Technical Service Bulletin: TSB220043

New Diesel Exhaust Fluid (DEF) Controller Causing Line Heater Fault Codes: 3258, 3261, and 3425

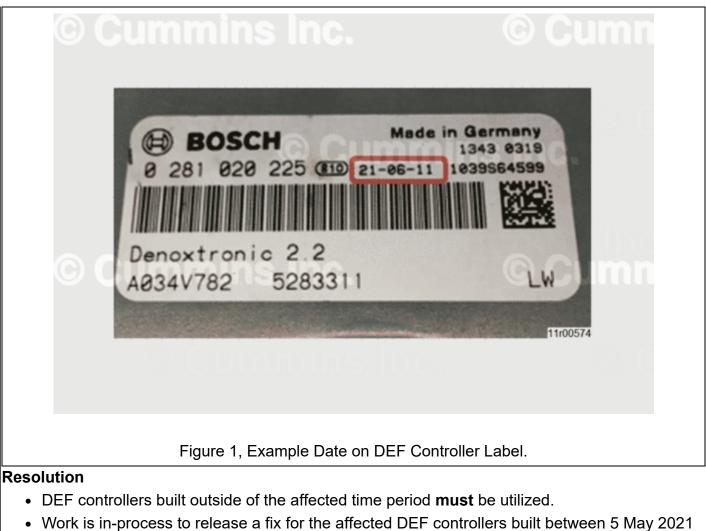
- DEF controller compatibility issue causes the DEF controller to fail the internal line heater diagnostic test and triggers line heater fault codes when the line heater circuit is activated.
- This issue affects DEF controllers, Part Numbers 5283311 and 5283311RX, built between 5 May 2021 and 15 December 2021.

- The build date code printed on the DEF controller is in YY-MM-DD format.
- Example Date: 21-06-11 is 11 June 2021. See Figure 1.
